RE: 122 Millhouse Road, Mooresville NC

Attached is the septic specification information required to permit 122 Millhouse Road for an Improvement Permit in Iredell County via the Expedited Review Process.

Meadow Fields Lot 4 Fast Track - The Oaks Group, PA

SOIL/SITE EVALUATION
for ON-SITE WASTEWATER SYSTEM

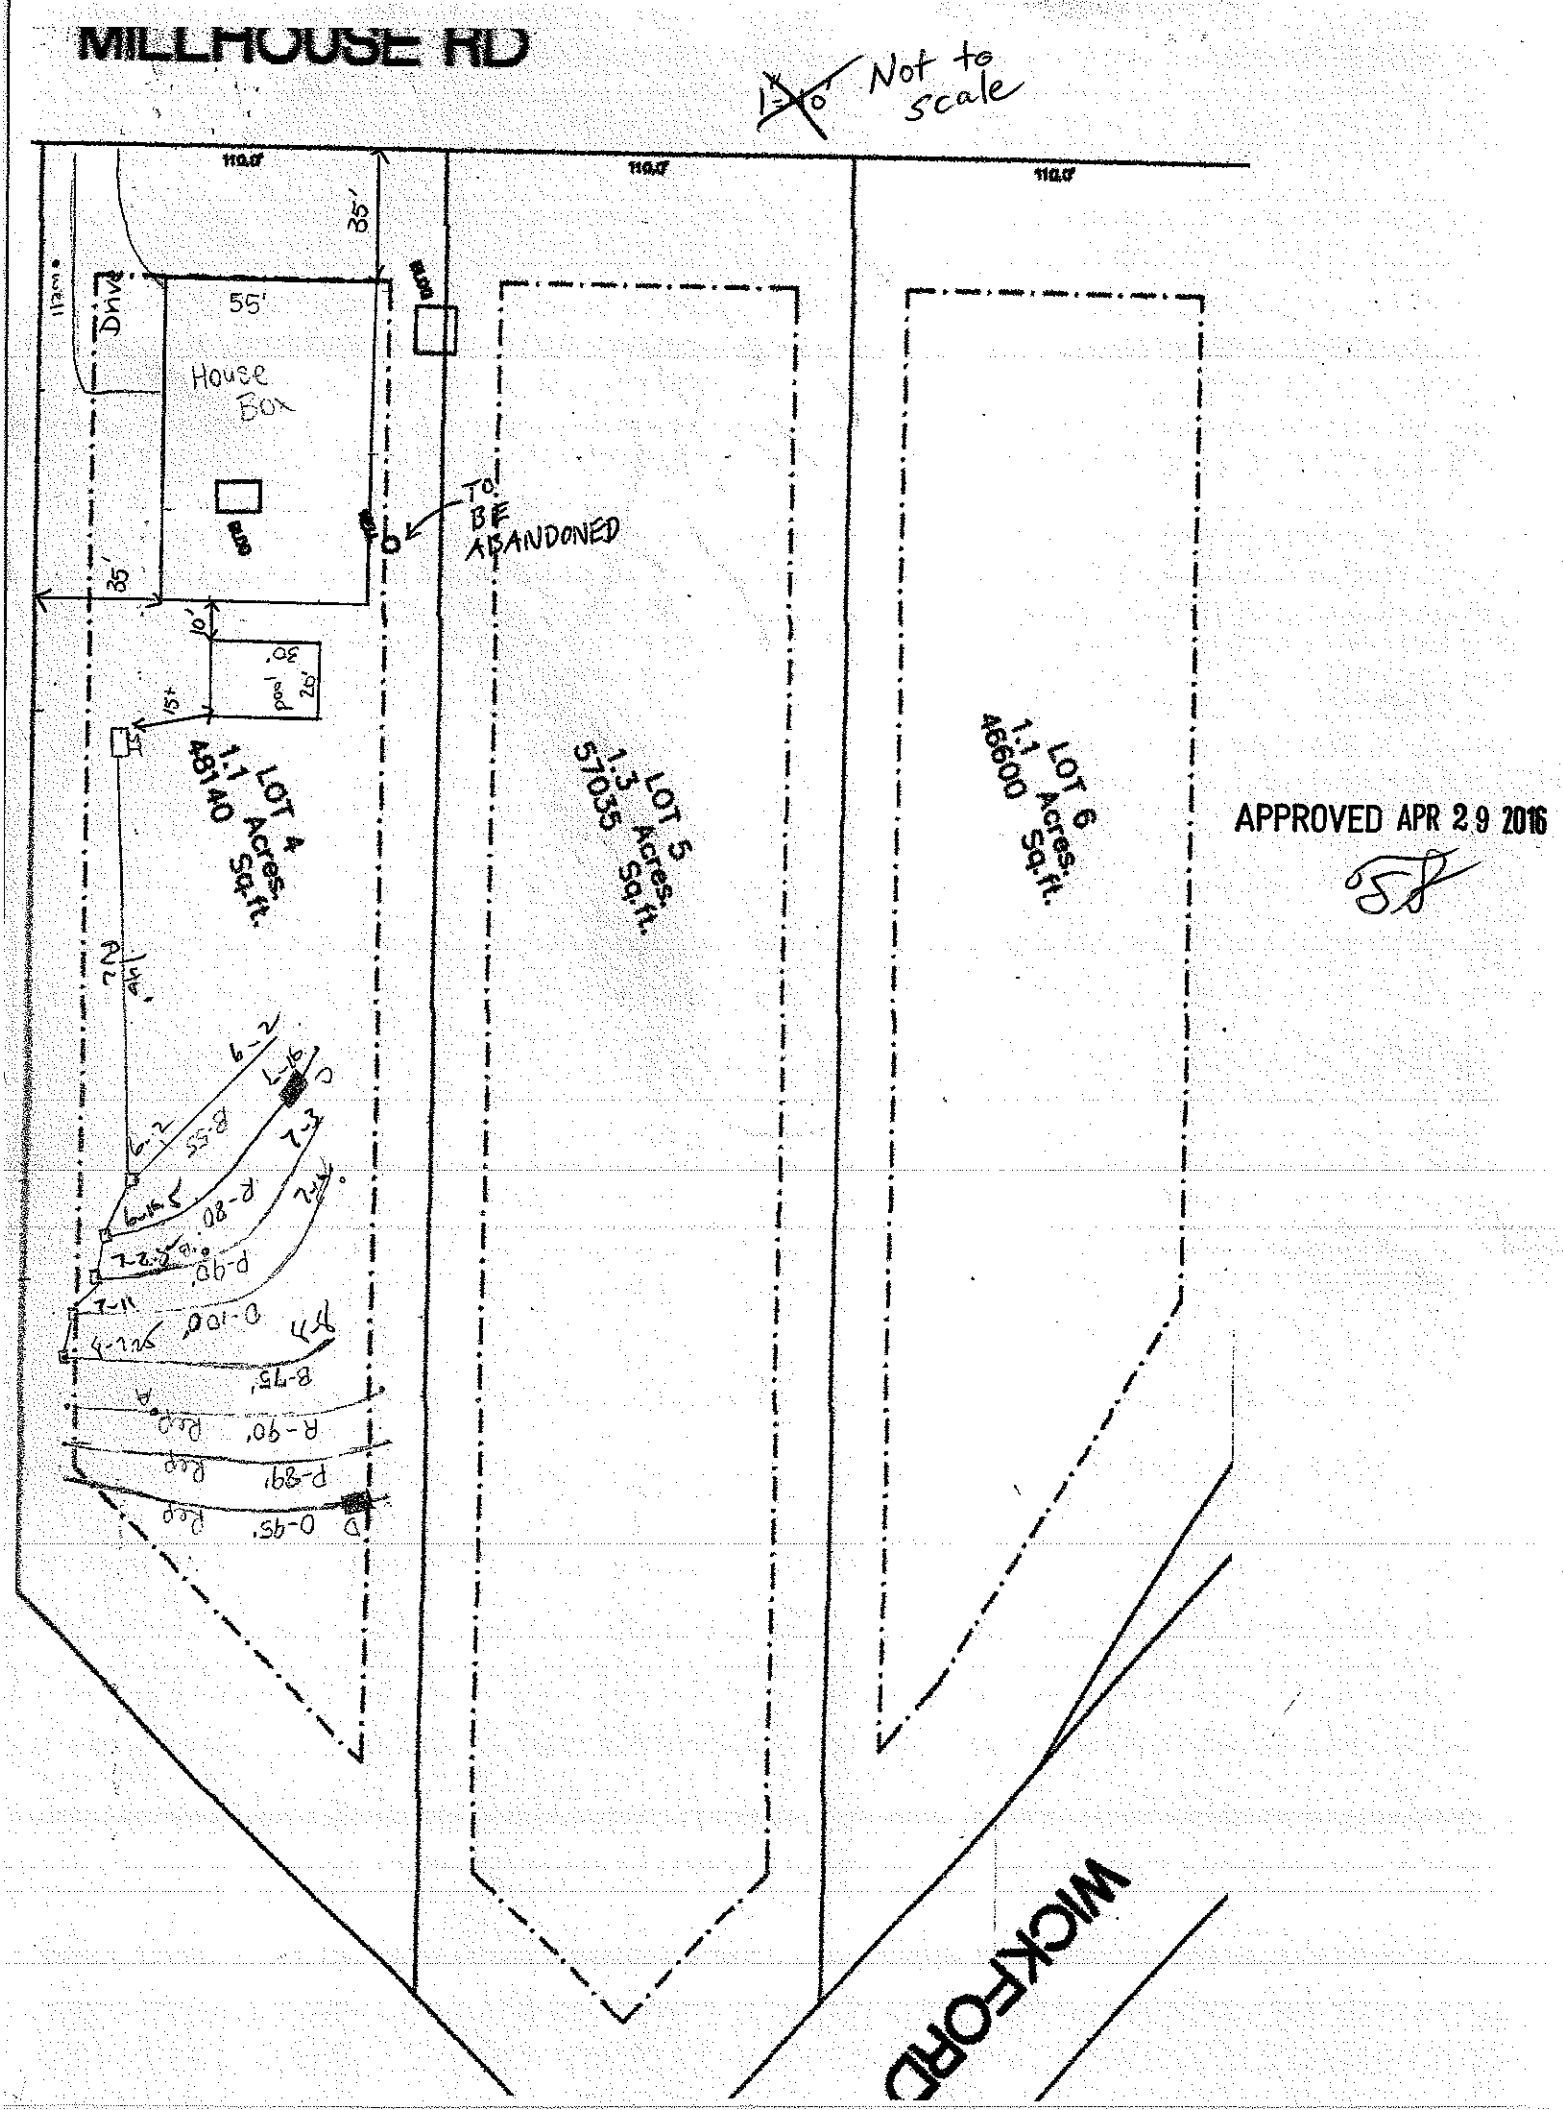
Note: Tank and distribution device locations can be altered at the discretion of ICHD.
Keep proper setbacks to foundation drains
Abandon existing well

COMMENTS: well must be abandoned
